**ADDENDUM NO. 2 TO PROJECT NO. 47412**

**CONSTRUCTION, HVAC, PLUMBING, AND ELECTRICAL WORK  
REHABILITATE KITCHEN, DINING HALL & COURTYARD  
FINGER LAKES RESIDENTIAL CENTER  
250 AUBURN ROAD  
LANSING, NEW YORK**

March 27, 2026

SHEET TITLE: FOUNDATION PLAN  
 DRAWING NUMBER: S-100  
 SHEET 36 OF 113

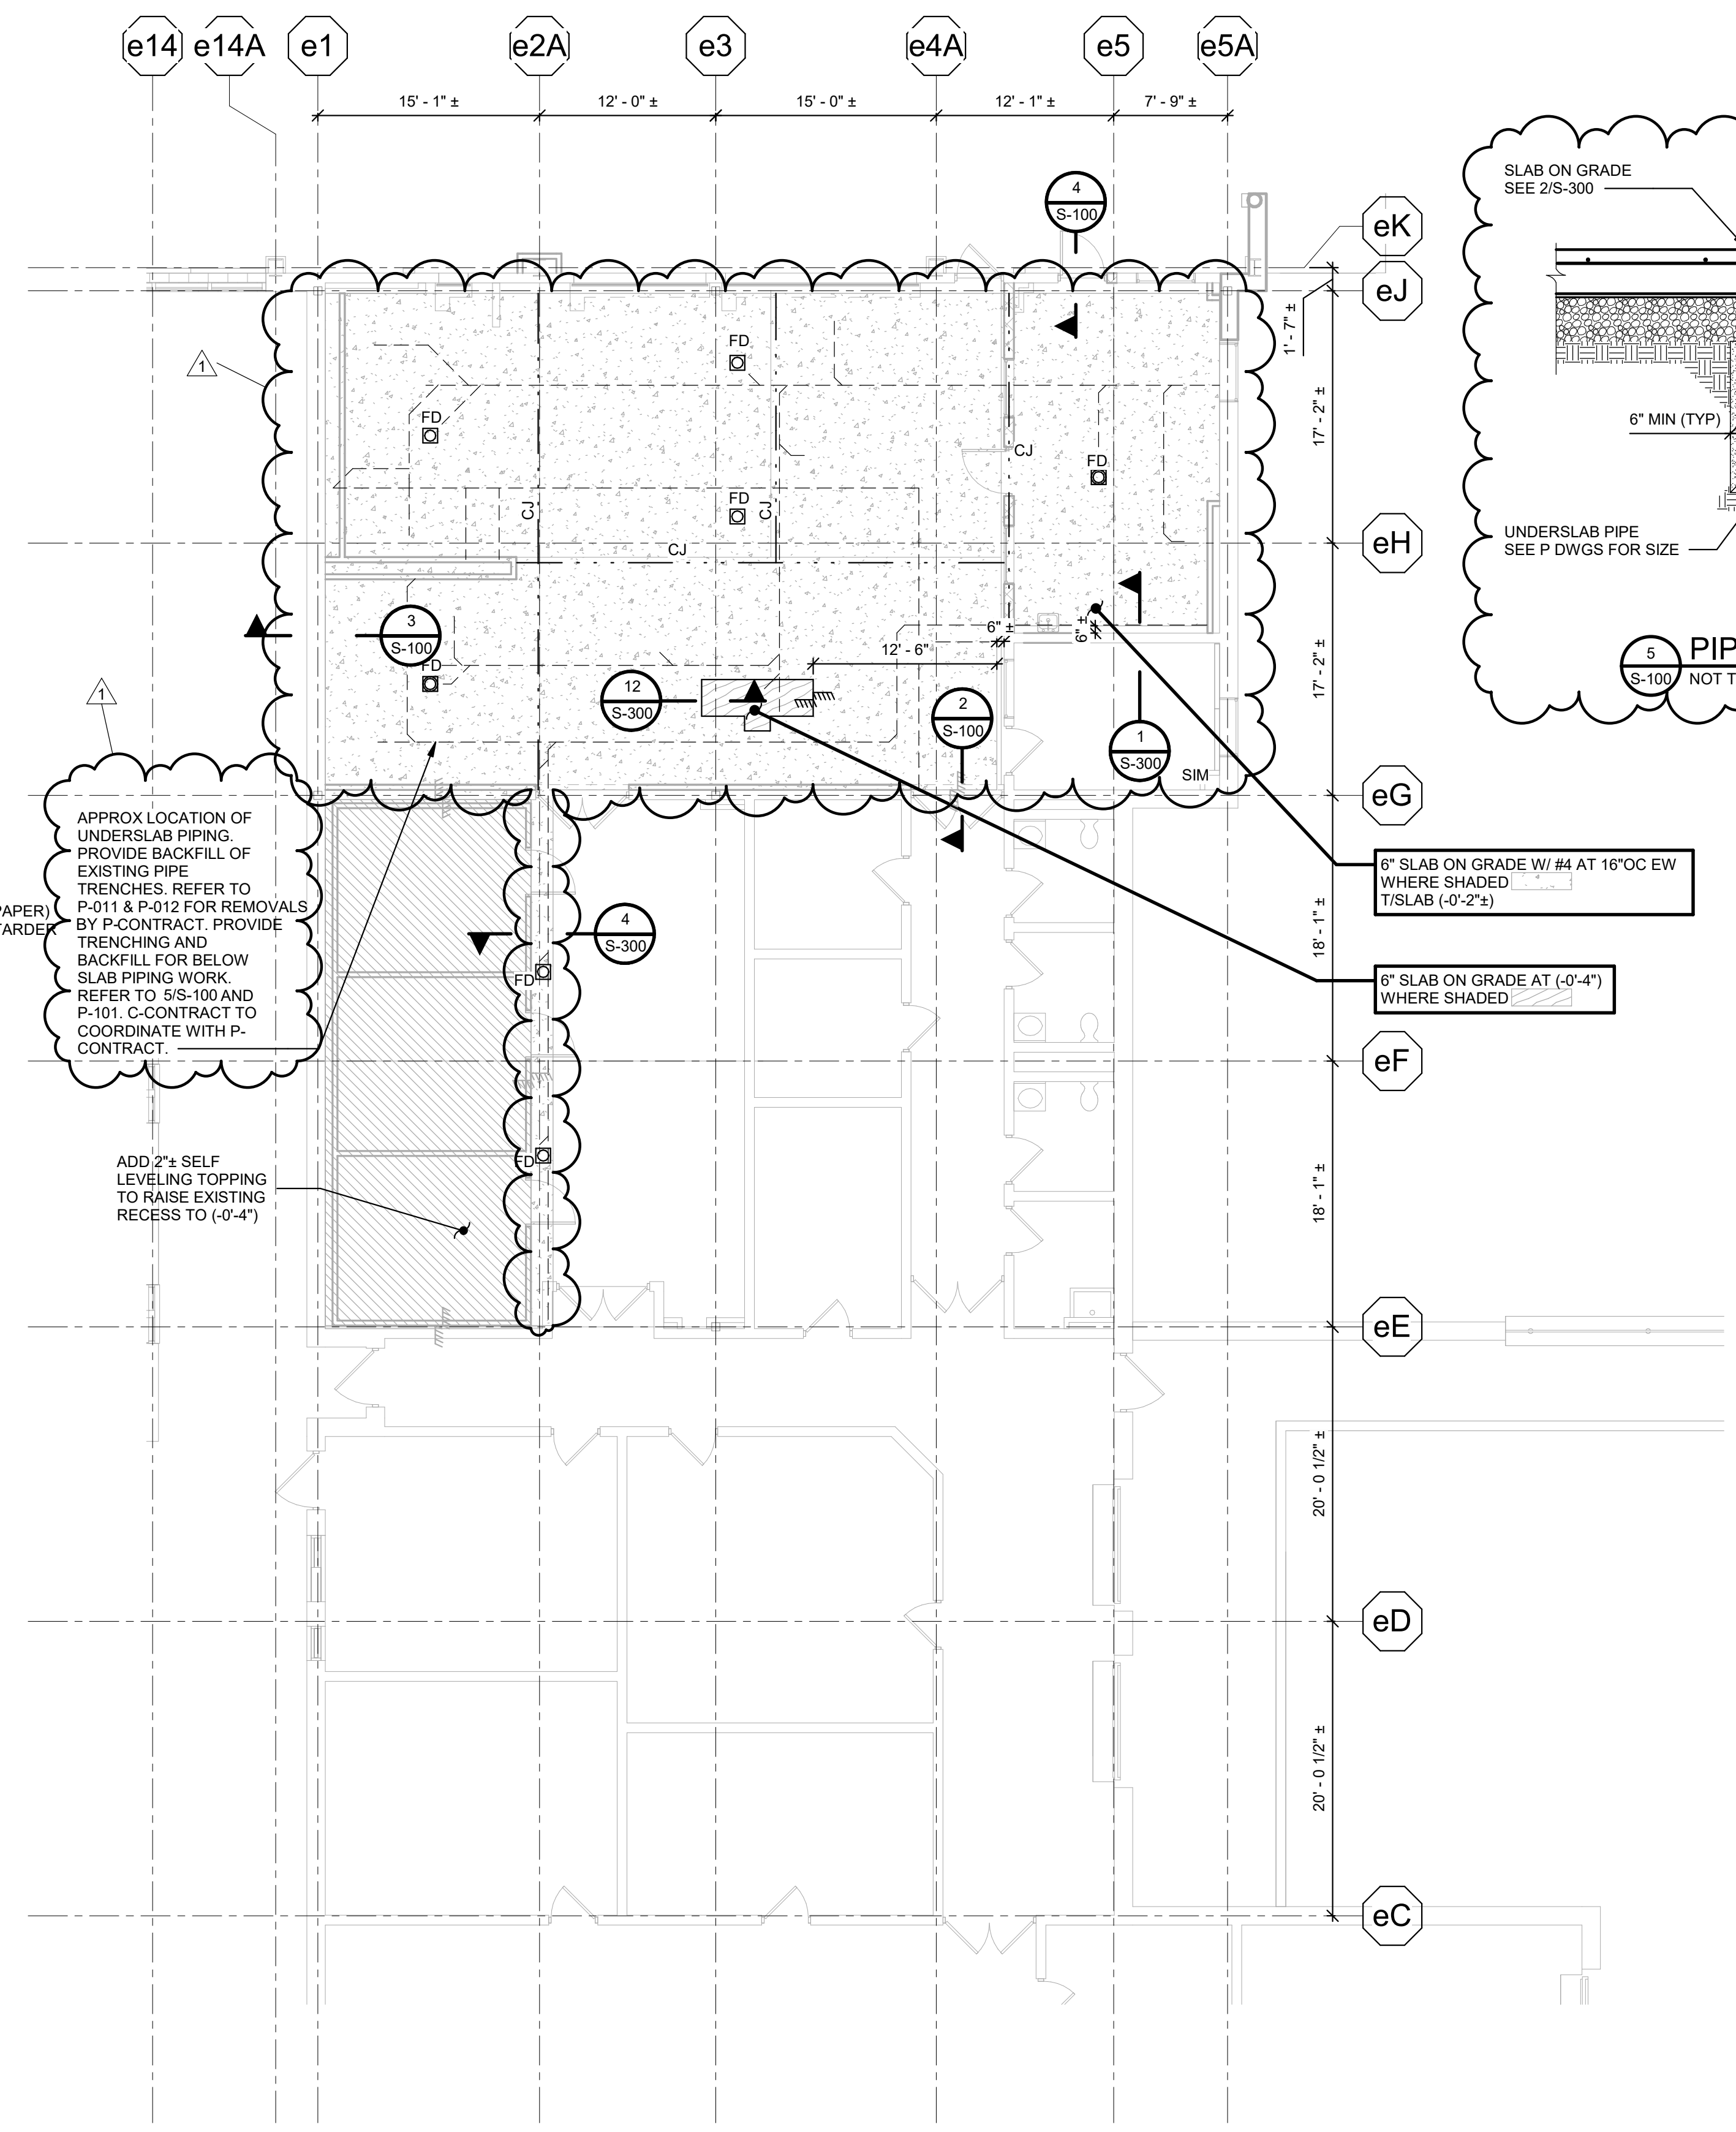
2. Revised Drawings:
  - a. Drawing Nos. S-100 and S-300, noted Revised Drawing dated 3/26/2026, accompanies this Addendum and supersedes the same numbered previously issued drawings.

“A. Excavate and remove below slab piping. Coordinate slab cutting for removals and new work with CC. Refer to S-100.

APPROX LOCATION OF UNDERSLAB PIPING. PROVIDE BACKFILL OF EXISTING PIPE TRENCHES. REFER TO P-011 & P-012 FOR REMOVALS BY P-CONTRACT. PROVIDE TRENCHING AND BACKFILL FOR BELOW SLAB PIPING WORK. REFER TO S/S-100 AND P-101. C-CONTRACT TO COORDINATE WITH P-CONTRACT.
